Executive Director's Recommendation

Commission Meeting: January 5, 2012

Travel Camp

Preliminary approval of site and building plans

Figure 5: Trav

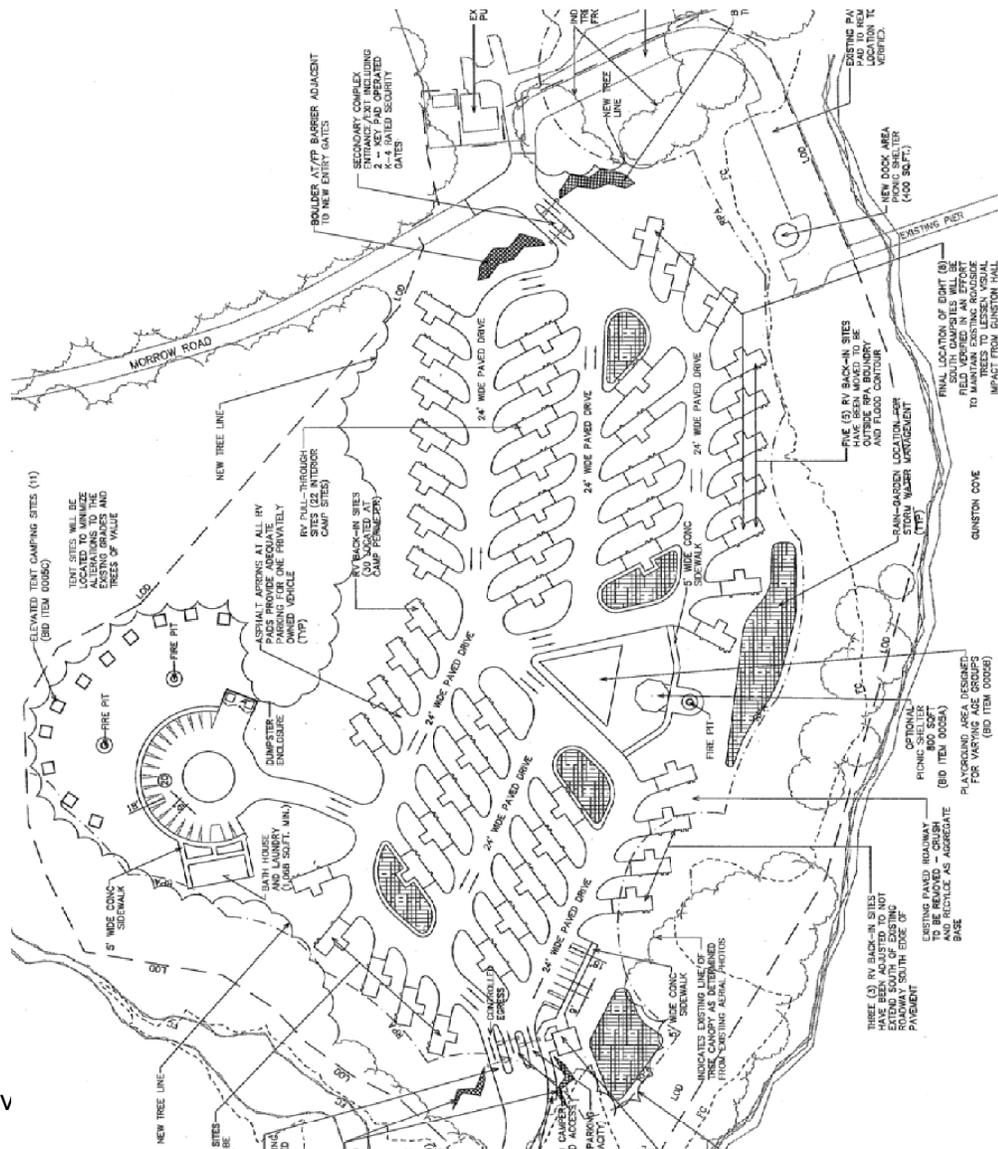
As indicated previously, the travel camp is separated into two sites. In addition to the RV parking pads, the RV area will also include a check-in building, a shelter, a Bath House/Laundry facility, and an area for twelve (12) platform tent sites (Figure 5). While most of this site is to be constructed on existing paved area, the Army has indicated that a portion of the proposed

development will require the removal of some wooded areas. The amount of wooded area to be removed was not identified.

Figure 6: Travel Camp – Cabin site layout

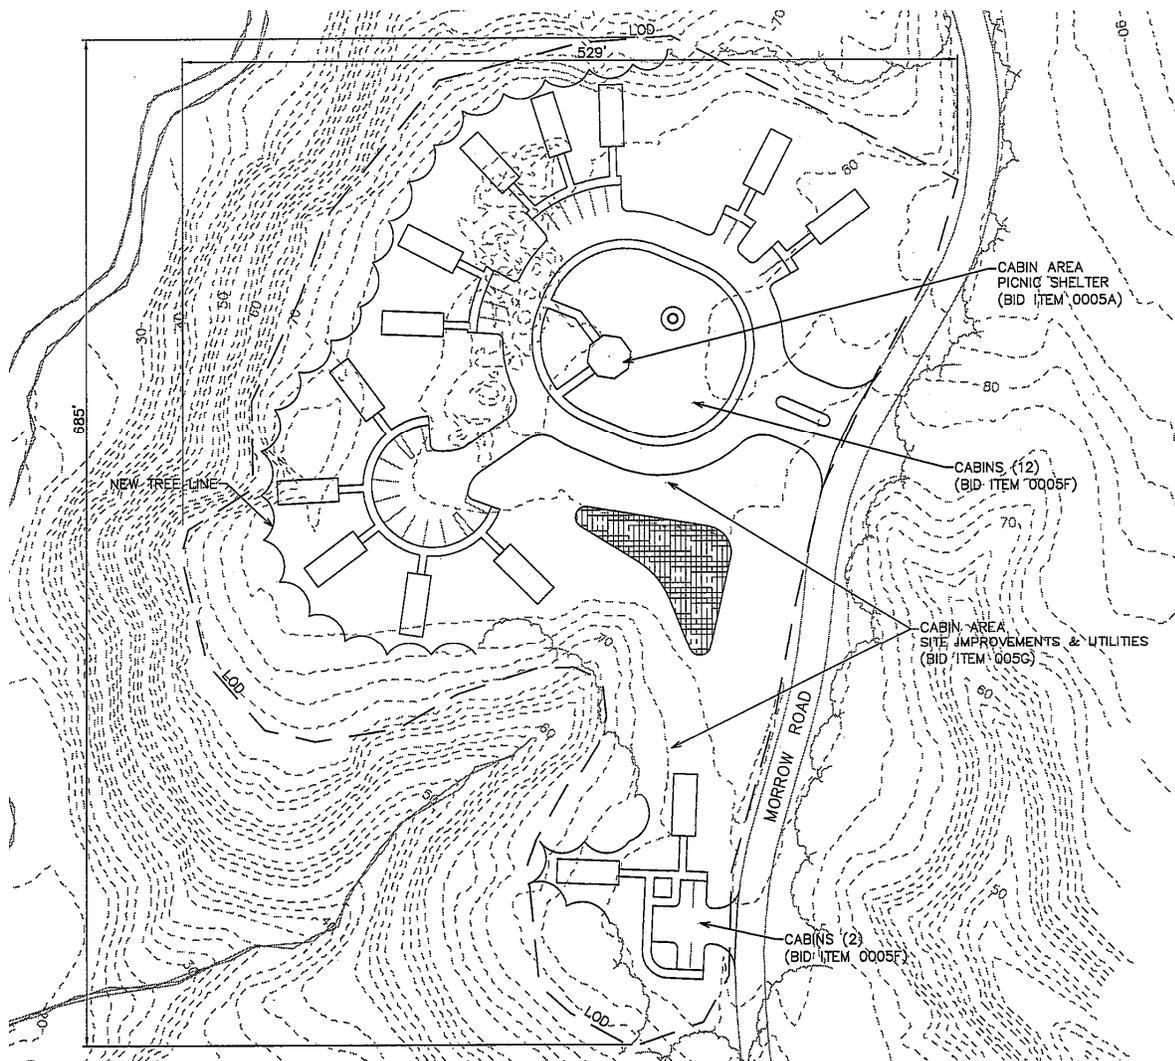
The proposed northern site for the travel camp includes fourteen (14) cabins organized around a cul-de-sac. In order to provide spacing for each of the cabins the Army has indicated that some trees along the western portion of the site will need to be removed. The Army did not specify how many trees would need to be removed for the cabins.

- **Submit a detailed landscape plan that describes the amount of tree loss and the project's conformance to the Fort Belvoir tree replacement policy**
- **Reconfigure the cabin area to reduce its footprint to avoid any tree loss; and**
- **Evaluate the relocation of the existing pier parking lot out of the Resource Protection Area.**

The County recommended that clearing for the cabin site should be avoided within areas characterized by slope gradients of 15 percent or greater and it was unable to tell grade with the drawings submitted. A policy of the Comprehensive Plan in the Environmental Element also states that the federal government should “discourage development in areas of identified high erosion potential, on slopes with a gradient of 15 percent and above, and on severely eroded soils.” Therefore, the Army should evaluate the proposed design to ensure that it is not proposing development, grading, or tree cutting, on slopes of 15 percent or greater. While staff notes that the Army is not required to this local policy, we encourage the Army to work with staff and Fairfax County on the proposed impact to the County's EQCs as the EQC policy's goal is to protect ecologically important land for protection and restoration of the Chesapeake Bay watershed.

- In the northern portion of the project area, clearing should be avoided within areas characterized by slope gradients of 15% or greater. It is not clear from drawing number C-103 of the submission package if this is intended.

Figure 7: Resource Protection Area Boundary

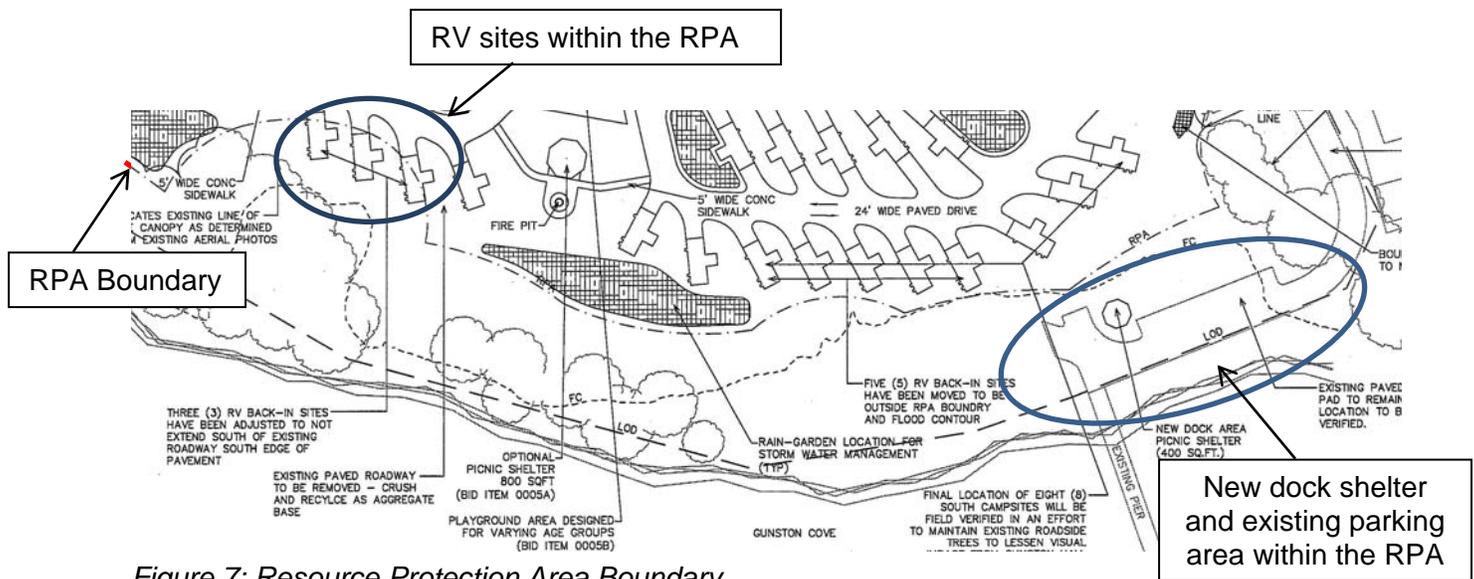
The County noted that it provided comments on the travel camp during the Environmental Assessment process and that those comments focused on the encroachment into the Resource Protection Area (RPA)¹ and the lack of conceptual stormwater plans. Fairfax County noted that there seemed to be improvement in the design regarding encroachment into the RPA, however still had concerns on the placement of a new dock picnic shelter and three RV back-in pads in the RPA. RPAs provide ecological benefits by providing water quality maintenance and pollution control as well as flood and erosion control. Staff agrees with Fairfax County that development in the RPAs should be minimized to the maximum extent possible in order to protect this ecological benefit.

- Three of the RV pads would be located at least partially within the RPA. What is the justification for this encroachment? The RV pads should be relocated such that they would not encroach into the RPA.

- As recommended earlier, the remaining proposed encroachment into the RPA for the RV pads should be avoided, and the cleared portions of the RPA (which would, in this area, include the EQC) should be restored.
